ADDENDUM NO. TWO
11/04/2025

PROJECT: **EULA ISD**
BUS & MAINTENANCE FACILITY

BID DATE: **NOVEMBER 13TH, 2025**

SITE PLAN

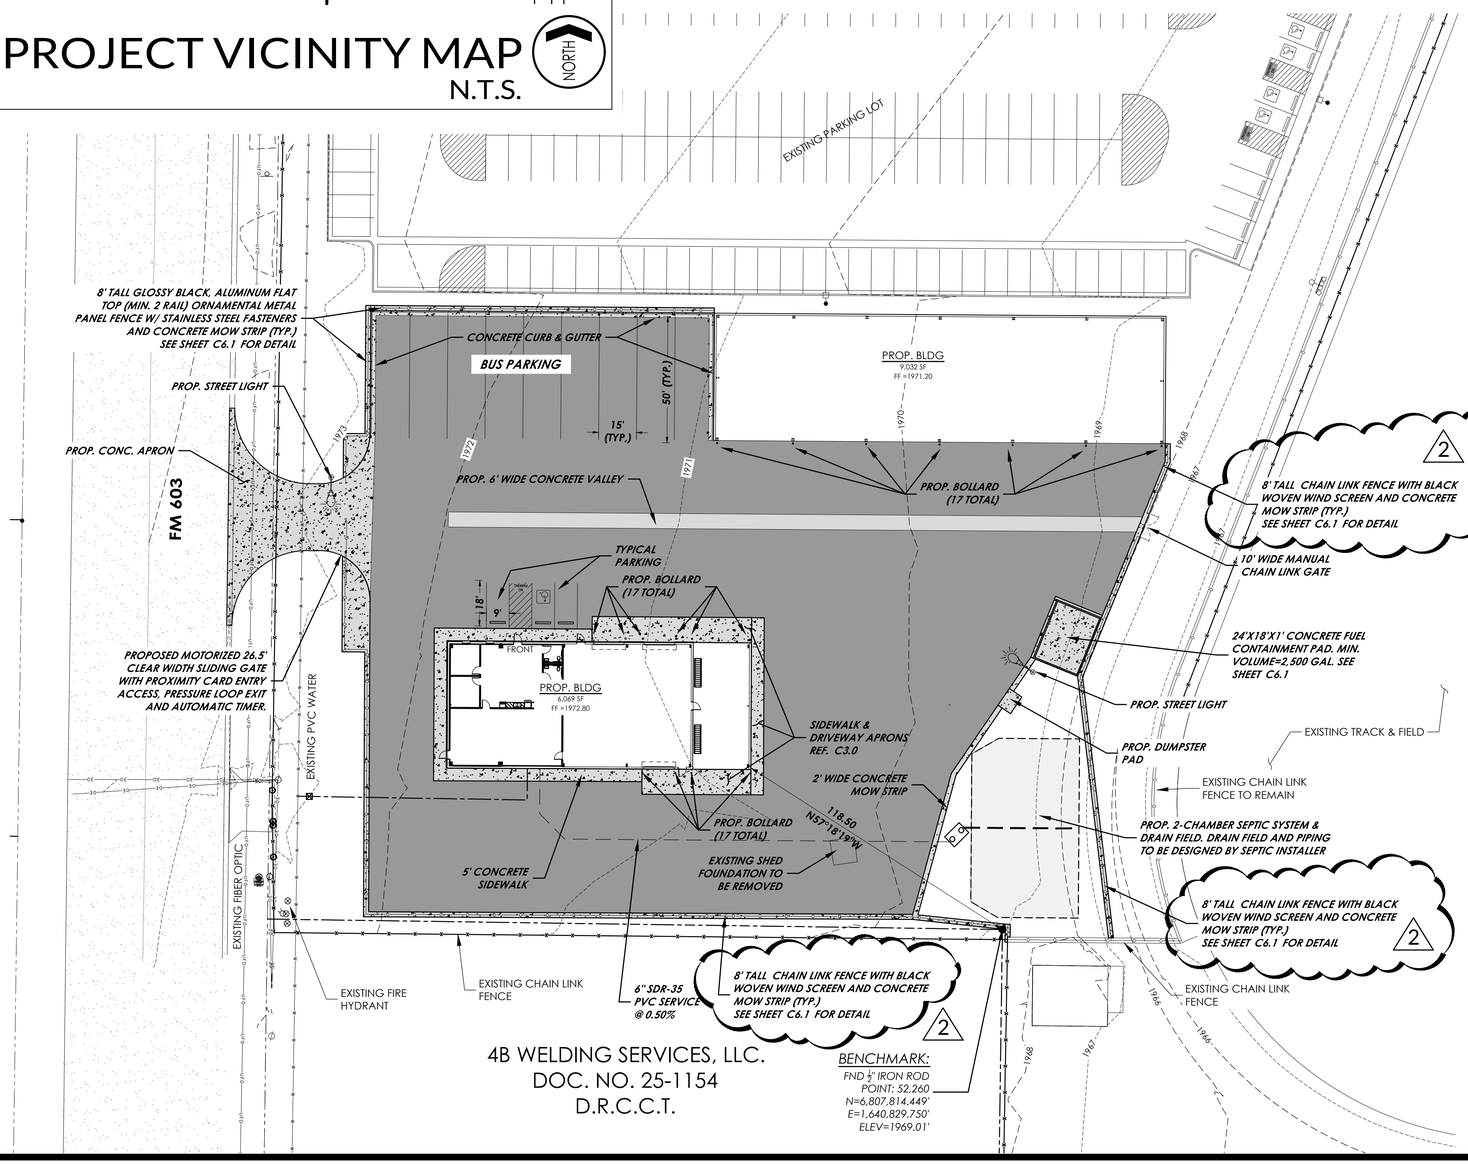
Item #D1 **Sheet C1.0** – REPLACE sheet with attached sheet C1.0 dated 11-03-2025. UPDATED site plan changing two fence call outs to be chain link fence with black woven wind screen. Front fence along FM 603 to south corner and north fence to remain 8' ornamental fence.

Item #Q2 **Question:** The plans call out a 10' ft chain link double gate in the middle of the ameristar fence. Is this supposed to be ameristar fencing to match the rest of the fence or will it remain chain link?

Answer: This fence is intended to be chain link fence; see updated civil sheet C1.0.
